ADDENDUM NO. 02

PROJECT NAME: Hemisfair Internal Street Improvements: Water and E. Nueva

DATE: October 8, 2014

TCI PROJECT NO.: **40-00421**

DSN: RAW	CK: -	DATE	JOB NO.	SHEET NO.
DRN: CRA	CK: -	SEPT. 2014	218609	71

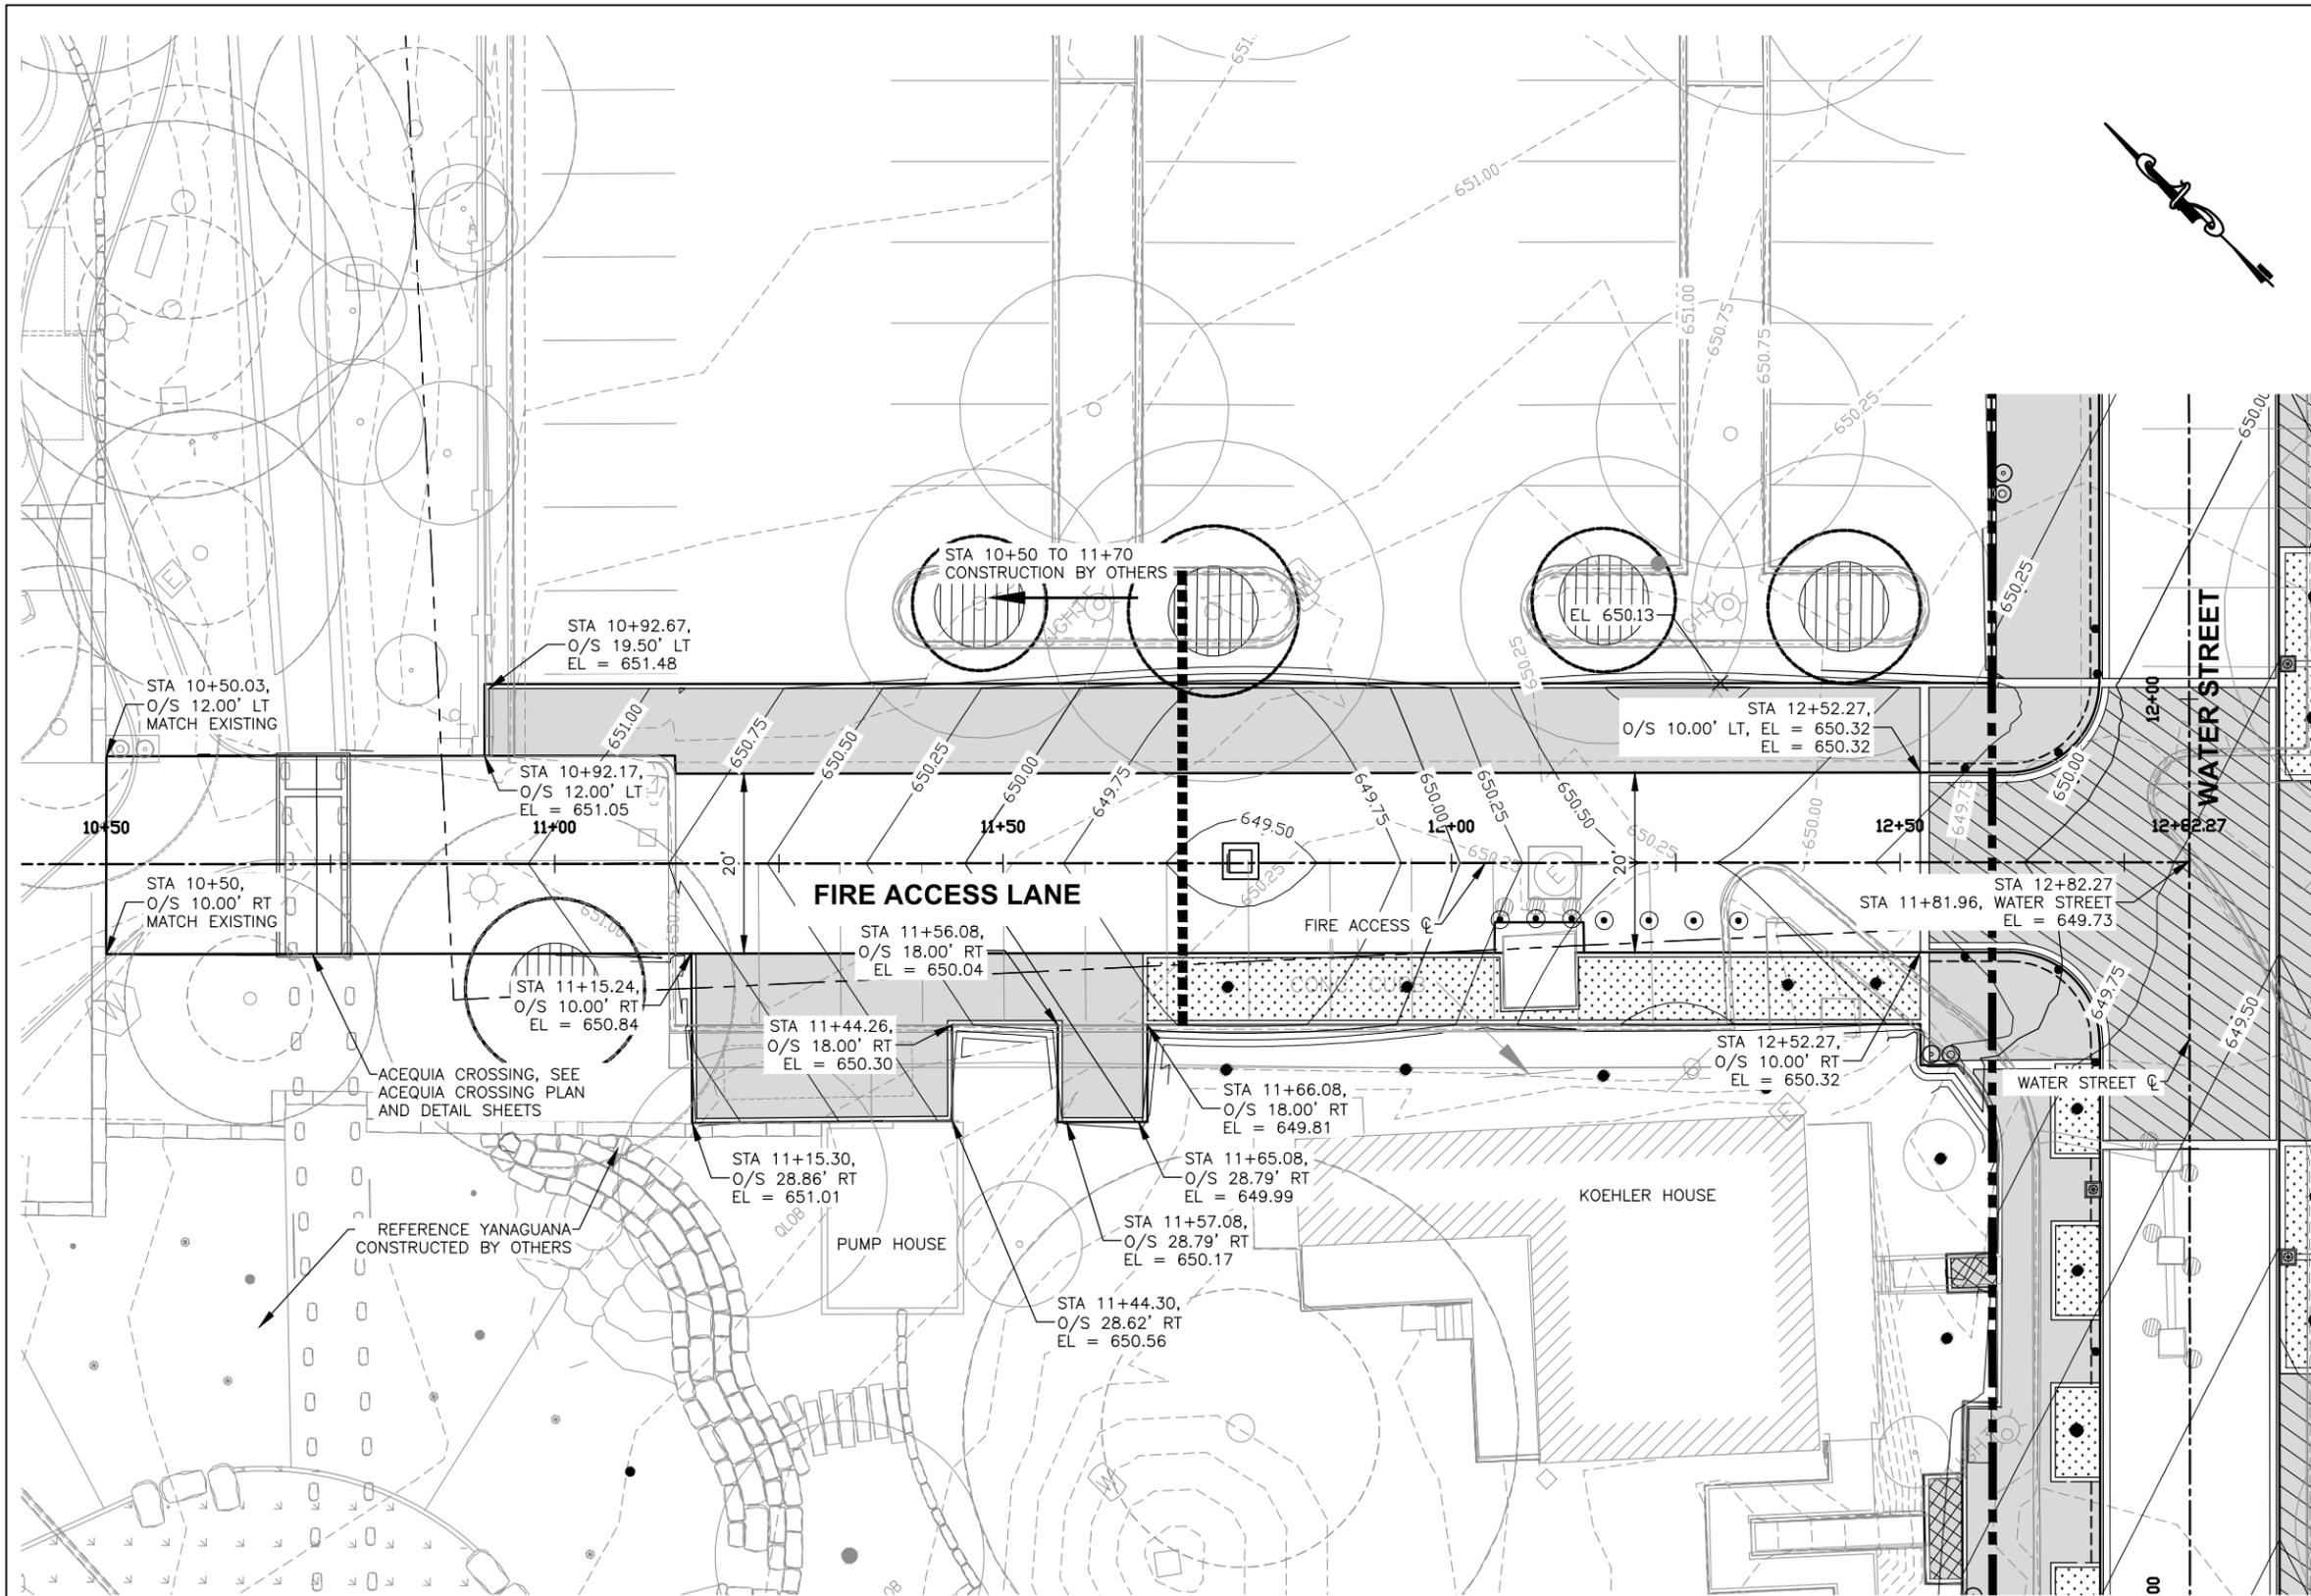
- Sheets 59-65 – Plan and Profile: Updated roadway hatching
- Sheet 67 – Plan and Profile: Updated roadway hatching
- Sheet 71 – Grading Plan: Updated roadway hatching, Added callout for combination curb

DSN: JMG	CK: SDT	DATE	JOB NO.	SHEET NO.
DRN: CRA	CK: -	SEPT. 2014	218609	72

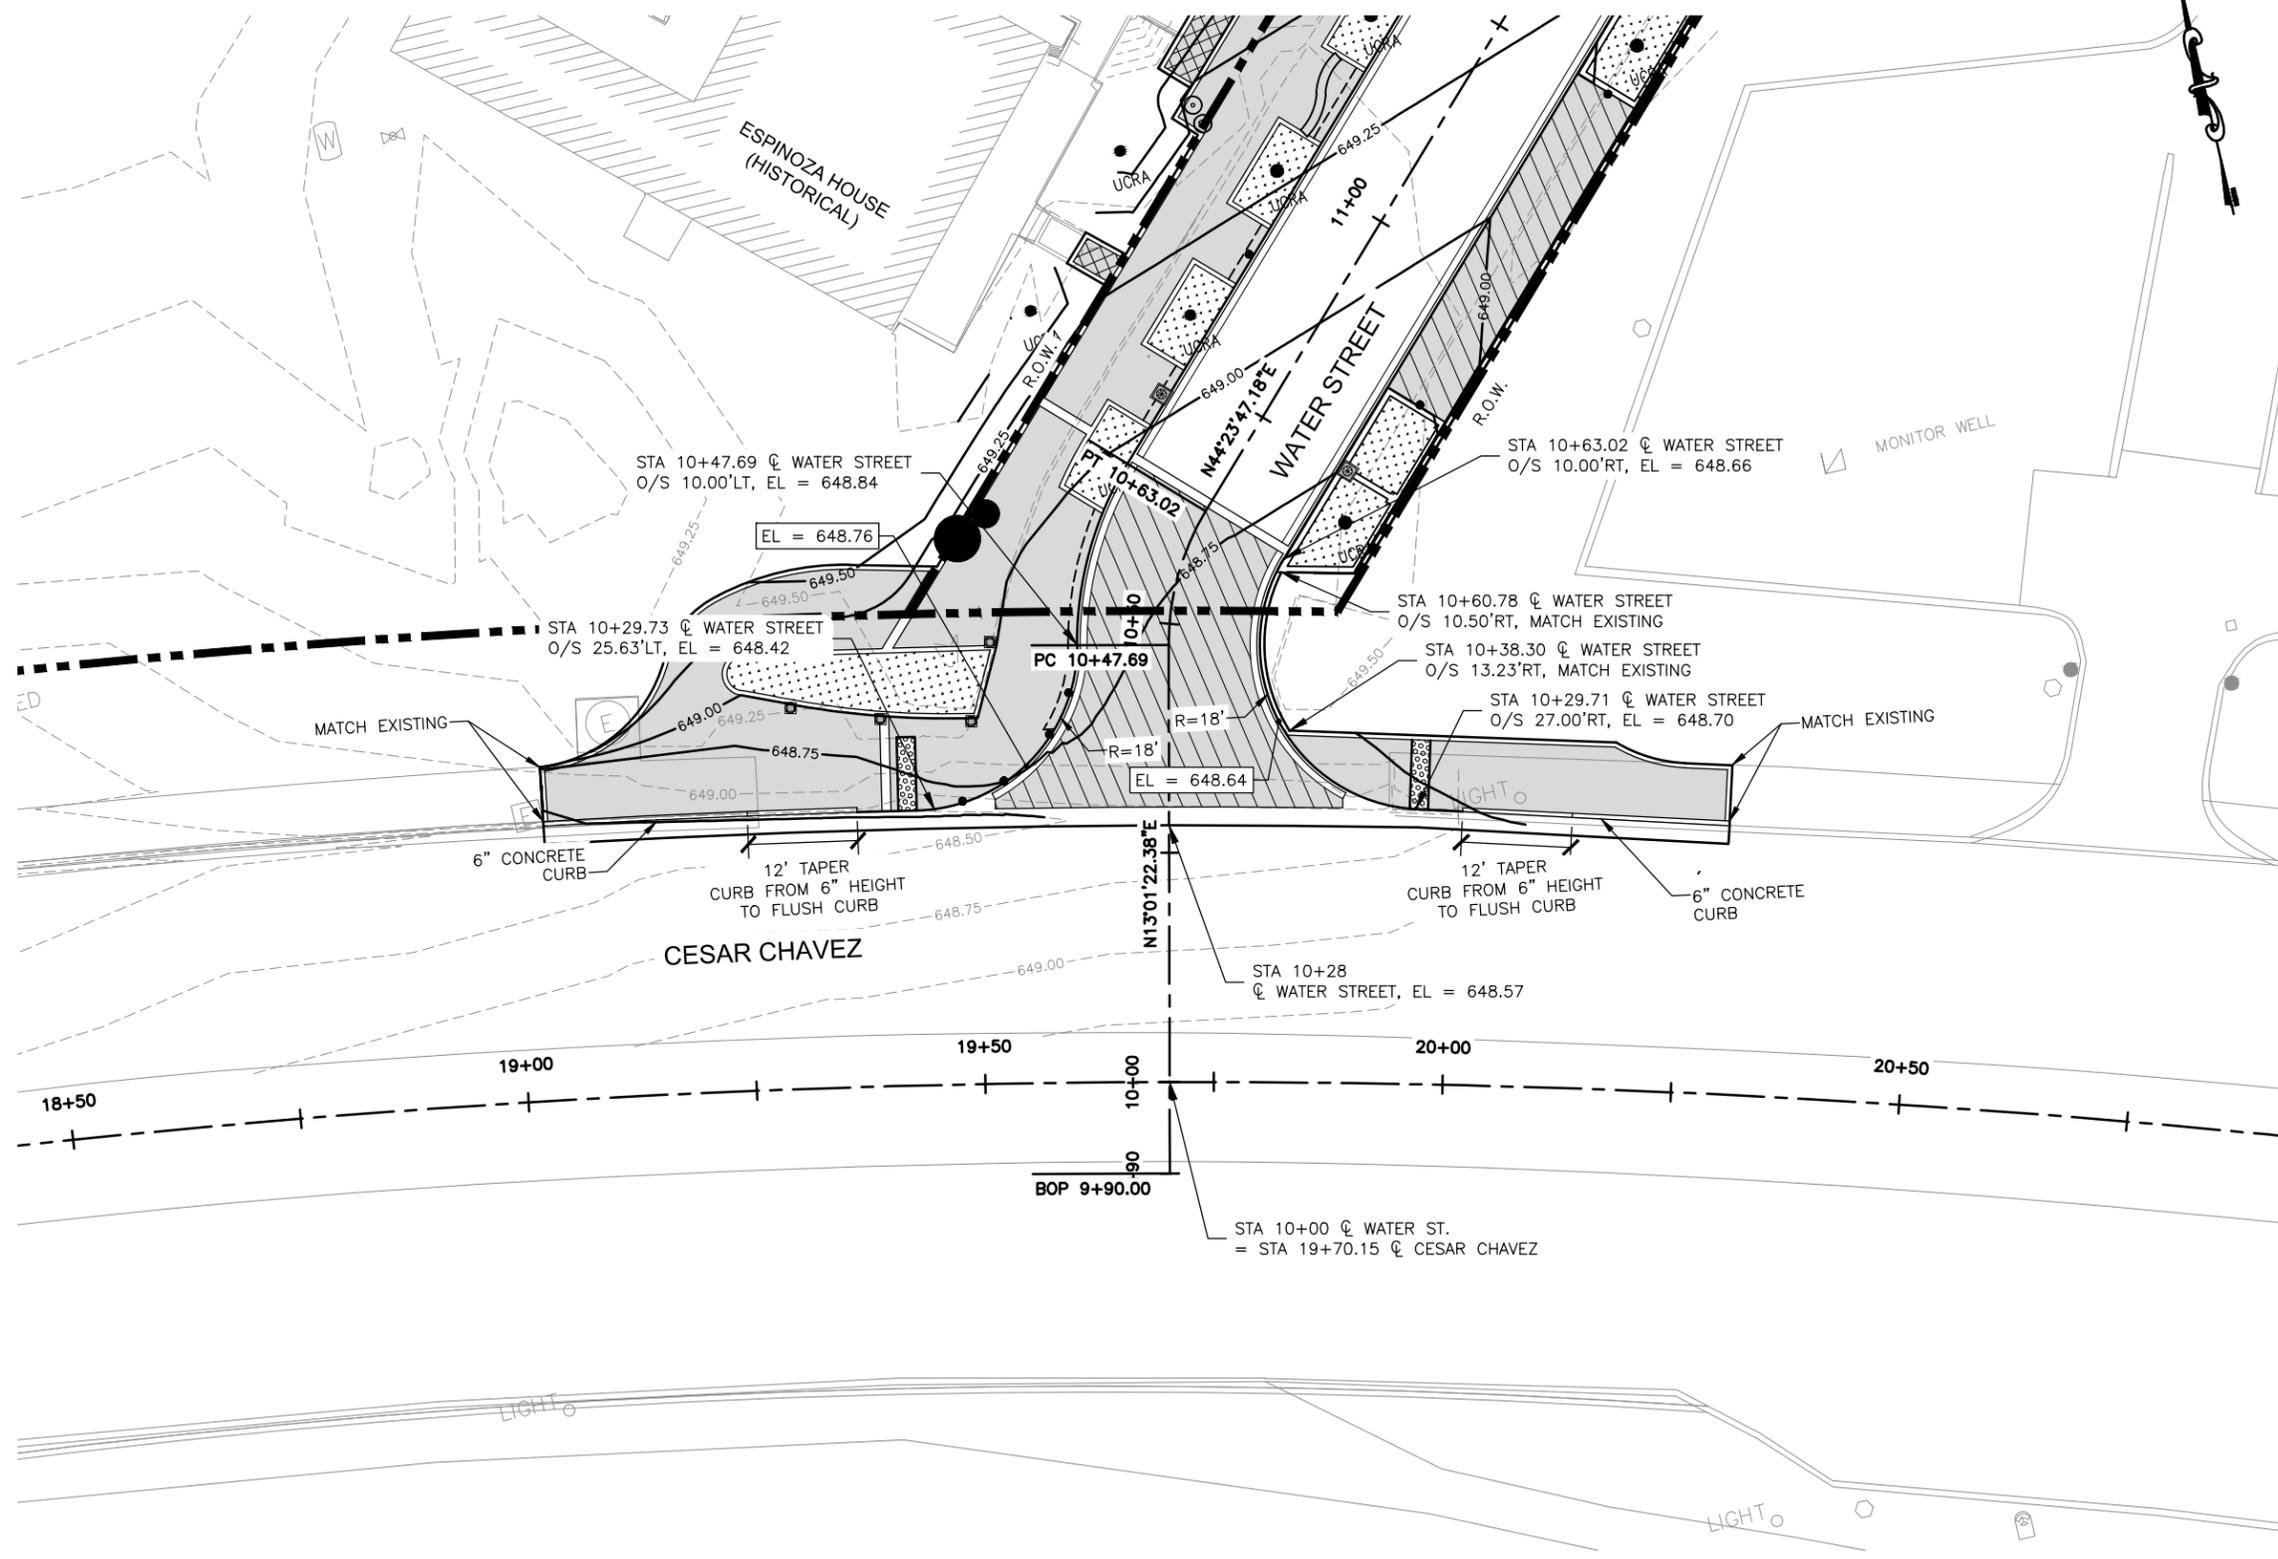
- Sheets 72-73: Grading Plan: Updated roadway hatching
- Sheet 92 – Drainage Plan and Profile: Added note for inlet to be removed
- Sheet 112 – Environmental, Permits, Issues, and Commitments: Updated language
